ANADROMOUS WATERS CATALOG/ATLAS
CORRECTION FORM

Describe Change(s): Changes involve corrections to annotation where fish species codes are missing or AWC# is in error

Nomination Number: CB-368

From: Barnhill, Carol A (DFG)
Sent: Friday, February 13, 2009 6:19 PM
To: Johnson, J D (DFG)
Subject: AWC species errors

COsr,Ss,DVsr
COsr,Ss,DVsr
CHs
Creek
200-20-10110-2031-3055
Powers
Falls
Creek
Ss
200-20-10110-2031-3060
Ss
Ss
Ss
CHs,COs,Ss
Mount
Hamilton
Cabin
500
1000
1500
2000
500
1000
500
500
33
34
35
4
3
9
10

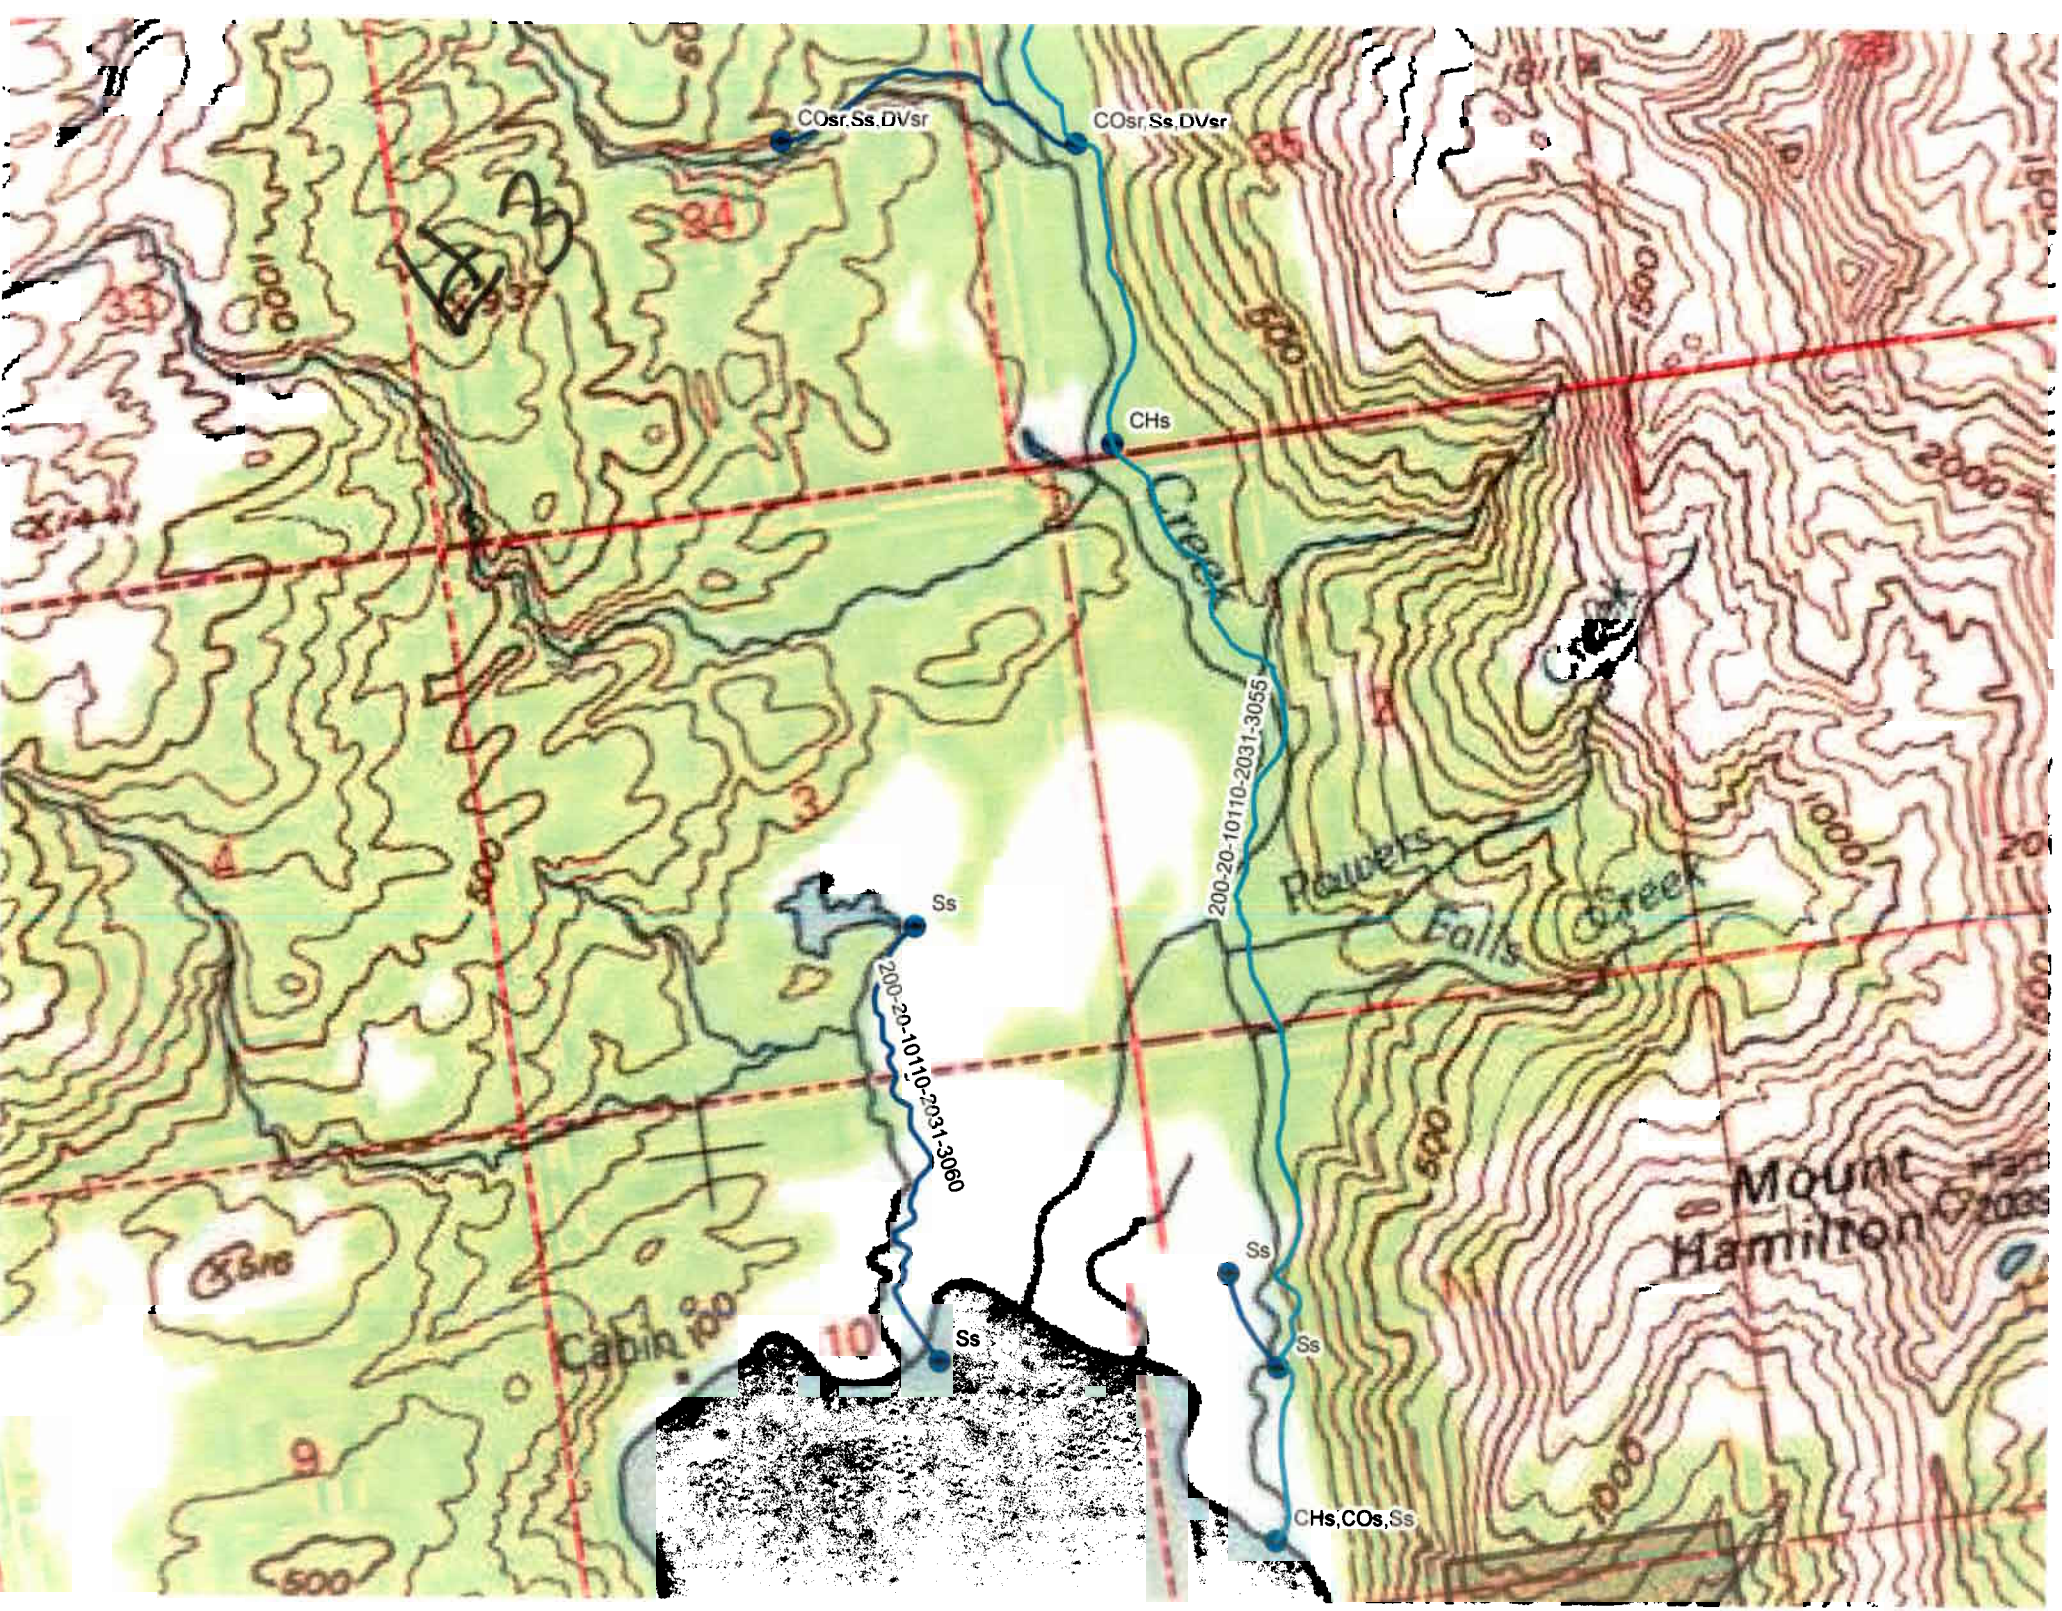
AWC#	Atlas map	Error on map	Corrective action
200-20-10110-2031-3032-4040-5015	Cordova B-1	No S in -5015	Add sockeye salmon to water body
200-20-10110-2031-3055	Cordova B-1	No DV in -3055	Add Dolly Varden to water body
221-10-10160-2150-3165	CORDOVA D-5	AWC # in error	Renumber as 221-10-10160-2051-3165
221-10-10160-2150-3175	CORDOVA D-5	AWC # in error	Renumber as 221-10-10160-2051-3175
221-10-10160-2150-3185	CORDOVA D-5	AWC # in error	Renumber as 221-10-10160-2051-3185
244-20-10090-2030	Kenai A-5	No DV at mouth of -2030	Add Dolly Varden to water body
244-20-10100-2019	Kenai A-5	No DV in -2019	Add Dolly Varden to water body
247-41-10200-2300-3011	Talkeetna A-1	No K in -3011	Add Chinook salmon to water body
247-41-10200-2053-3170-4027	Talkeetna A-2	No CO in -4027	Add coho salmon to water body
247-41-10200-2053-3170-4027	Talkeetna A-3	No CO in -4027	Add coho salmon to water body
247-41-10200-2053-3213-4050-0010	Talkeetna A-3	No Ss in -0010 (lake 1 pt)	Add sockeye salmon spawning to water body

1	244-20-10100-2019-3018	Kenai A-5	No DV in -2019
2	244-20-10090-2030-3032	Kenai A-5, A-4	No DV at mouth of -2030
3	200-20-10110-2031-3055-4019	Cordova B-1	No DV in -3055
4	247-10-10080-2010-3040-4010-5002	Tyonek A-6 & A-5	No CO in -4010
5	247-41-10200-2053-3229-4009-5105	Talkeetna A-4	No CO in -4009 (Also fix stream number in upper right map)
6	247-41-10200-2053-3170-4027-5033	Talkeetna A-2 & A-3	No CO in -4027
7	247-41-10200-2300-3011-4008	Talkeetna A-1	No K in -3011 (or 2300)
8	247-41-10200-2370-3041-4010	Talkeetna B-1	No S in -3041

#4
Straight
Ksr
DVr
247-10-10080-2010-3040-4010
COr
COr
Kr
Ss,DVs
Ps
247-10-10080-2010-3040
CHp,Sr,DVsr
Pp
COp
RAGHT CREEK
247-10-10080-2010
CHsr
Ks
CHsr,Kr,Ps,Ss,DVsr
15
16
13
18
17
23
24
24
20
21
22
25
26
25
30
29
27
28
33
34
35
36
36
31
32
1500
2000
500
1000
1030
660
665
475
300
R 15 W
R 14 W

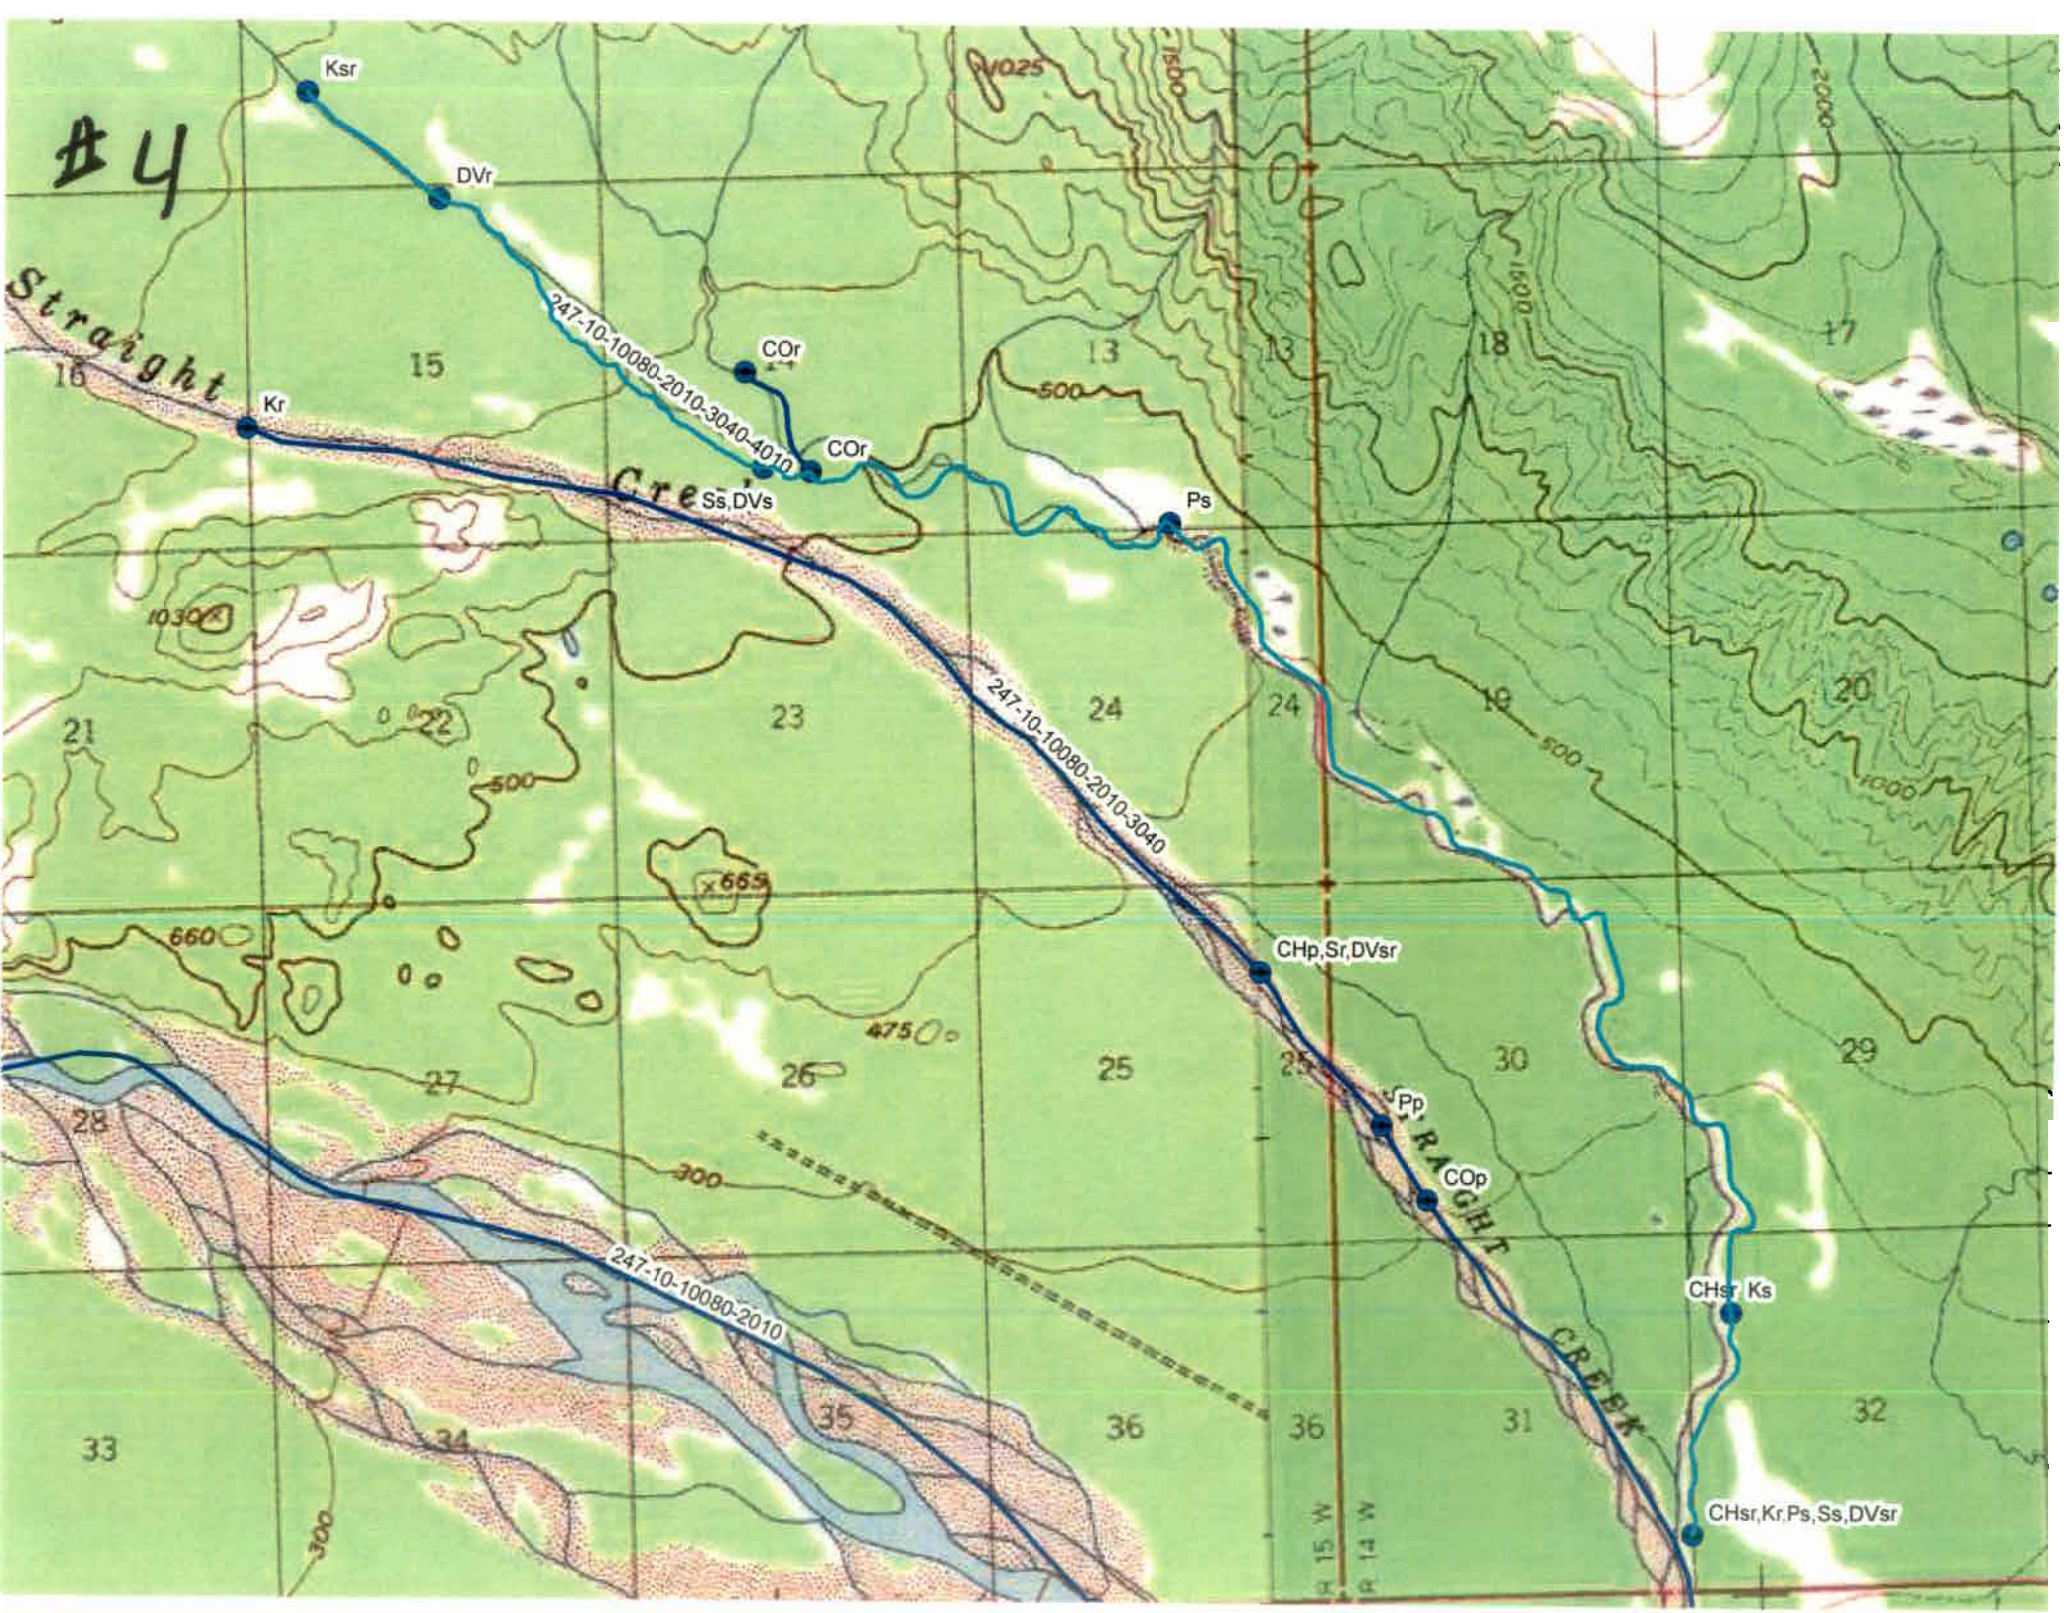
247-41-10200-2053-3220-4030	Talkeetna A-4	AWC # 247-41-2053-3220-4030	Correct to 247-41-10200-2053-3220-4030
247-41-10200-2053-3229-4009	Talkeetna A-4	No CO in -4009	Add coho salmon to water body
247-41-10200-2370-3041	Talkeetna B-1	No S in -3041	Add sockeye salmon to water body
247-10-10080-2010-3040-4010	Tyonek A-5	No CO in -4010	Add coho salmon to water body
247-10-10080-2010-3040-4010	Tyonek A-6	No CO in -4010	Add coho salmon to water body

#9
221-10-10160-2150-3185
COp
COp
221-10-10160-2150-3175
COp
COp
221-10-10160-2150-3165
COp
COp
221-10-10160-2051
COp
2000
2000
2000
12
12
11
NAT

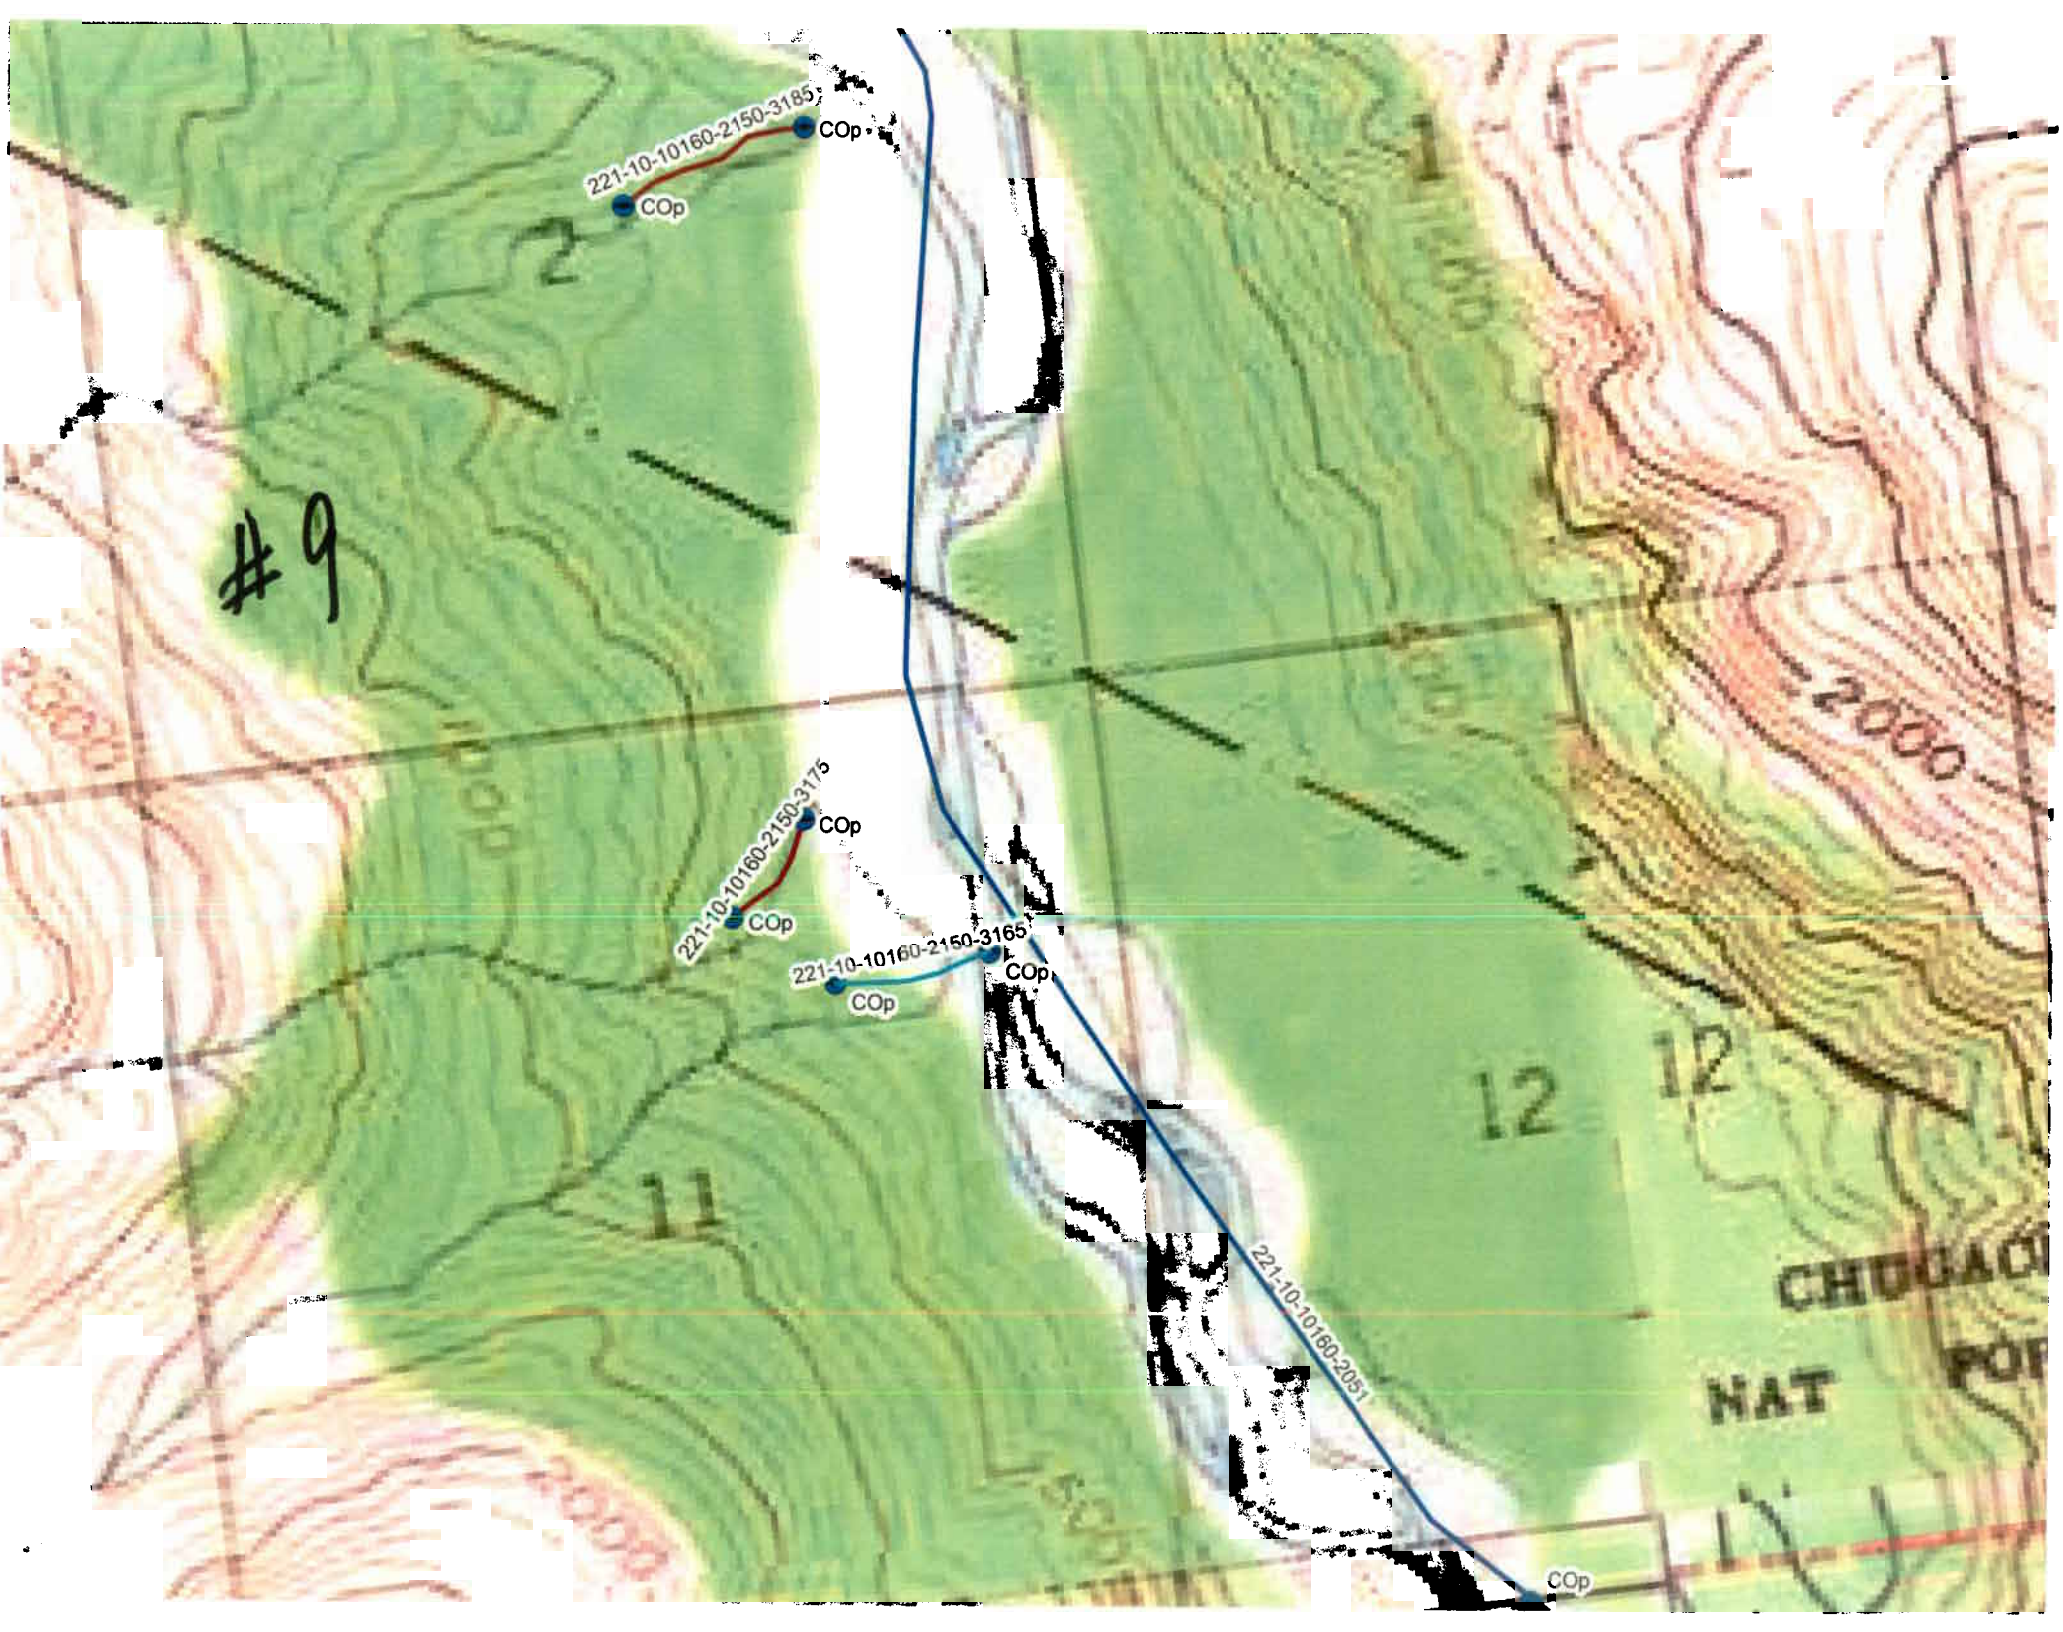
9 Streams 221-10-10160-2150-3165, -3175, & -3185 should be -2051-3165, -3175, & -3185 CORDS
